We would like to thank the reviewers for their thorough reviews and constructive comments on the manuscript. The original comments are shown in regular black font. The responses to reviewer comments are shown in blue font, with text describing proposed additions and revisions of the manuscript shown in red font. Any original manuscript text is shown in gray font.

## **Reply on Reviewer #2**

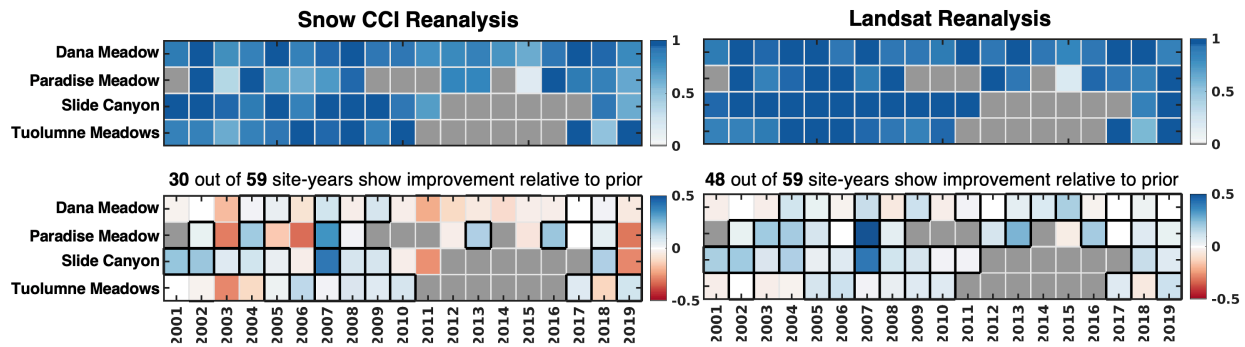
2. I have concerns about interpretations of differences in R correlation, particularly in Figures 7. A positive difference does not definitively mean that the correlation has improved, because R ranges from -1 to +1. For instance, a difference of +0.5 is not meaningful if the two R values are 0.0 and -0.5, as this indicates going from a weak negative relationship to no relationship at all. Hence, a positive difference in R is only a valid indicator of improved correlations when both are greater than 0. Why not just use  $R^2$  here to avoid any of this potential ambiguity?

**Response:** Thank you for your comment. We've plotted the temporal correlation using  $R^2$ , and the results remain consistent with the original analysis. We propose to replace the original figures with those below based on your suggestion.

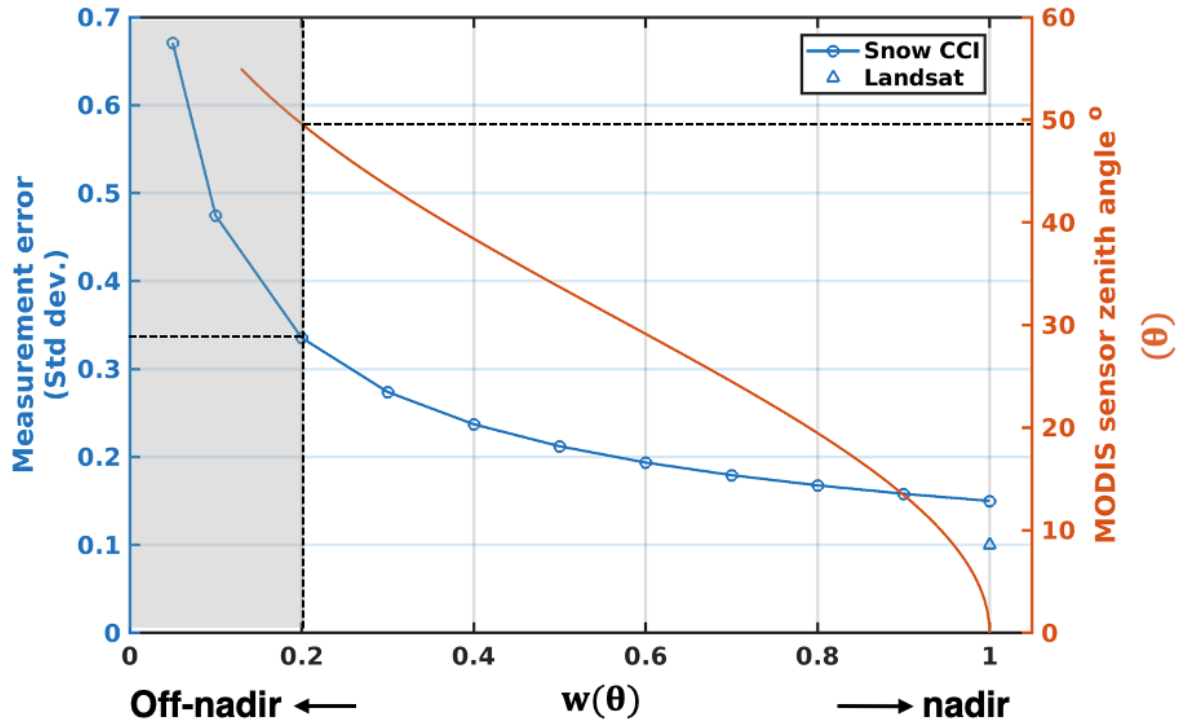
L.214-220 and Figure 3: What is theta angle for  $w(\theta) \approx 0.2$ ? It might help to add a second (non-linear) x-axis with the theta values, as this might be easier for some to interpret (i.e., satellite view angle).

L. 245: Again, it is hard for a reader to know what theta angle corresponds to weights of 0.2 or less. Describing in terms of theta is more straightforward, in my opinion.

Response: Thank you for your suggestion. We propose to add a second y-axis with the theta values. The theta angle for  $w(\theta) \approx 0.2$  is around 50 degrees.

Response: We propose adjusting Figure 3 (see above) to address this concern.

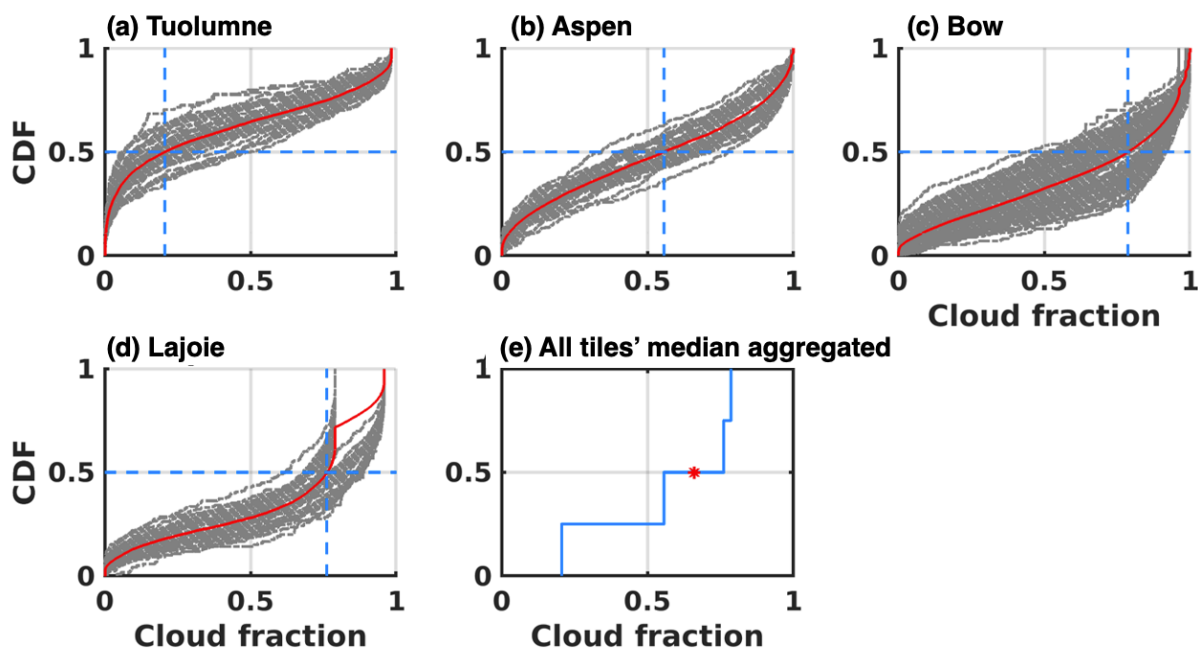
Figure 2: Why use the full water year for these distributions? I am not sure why summer (i.e., snow-free months) are relevant, especially given that Aspen may have cloudier summers than the other locations due to regular convective thunderstorms that occur over the Rockies. How would this figure (and thresholds) change if October-June was used instead of the full WY?

Response: Thank you for your comments. The attached figure shows the cloud threshold if October-June is used instead of full WY. The cloud threshold is about 0.66, which is similar (slightly higher) than the previously used threshold (0.6). Some implications of using different cloud thresholds are: using higher cloud thresholds result in eliminating more images, although certain pixels remain valuable. Otherwise, using lower cloud thresholds could result in including more cloudy images that likely misclassify snow as cloud.

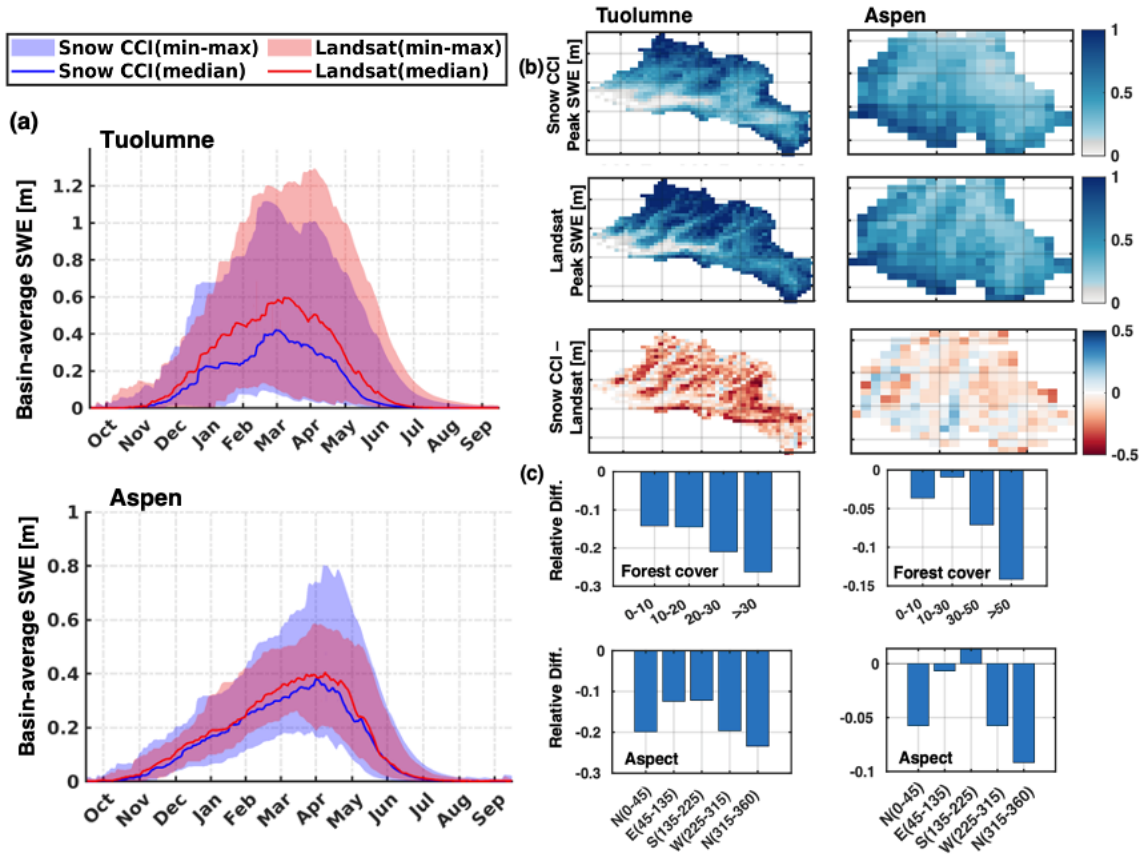
Figures 9 and 14: I have trouble interpreting the stacked shading here. Is there a better way to convey the ranges?

Response: We explored alternative ways to represent variability, such as using the full range (minimum – maximum) instead of 1-99<sup>th</sup> percentiles.

We propose to revise Figure 9 to:

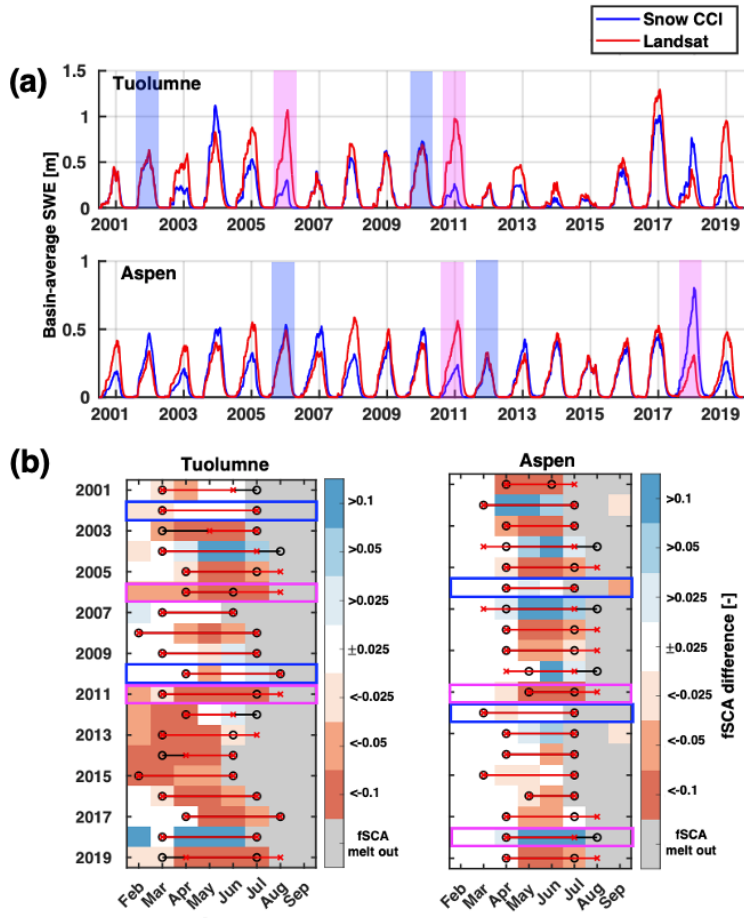
Figure 10: Looking at this figure and caption alone, it is impossible to discern what the blue and magenta shading represents. This comes later in Figure 11. Need to include the information in both places so your readers can understand.

Figure 10c: Suggest stacking these two panels vertically rather than horizontally so their common axis (Difference in peak SWE) is shared/aligned.

Response: We propose to add a description in the caption: Cases of consistent performance vs. inconsistent performance are highlighted in blue and magenta, respectively.

Response: Suggestion adopted. We propose to revise Figure 10 to:
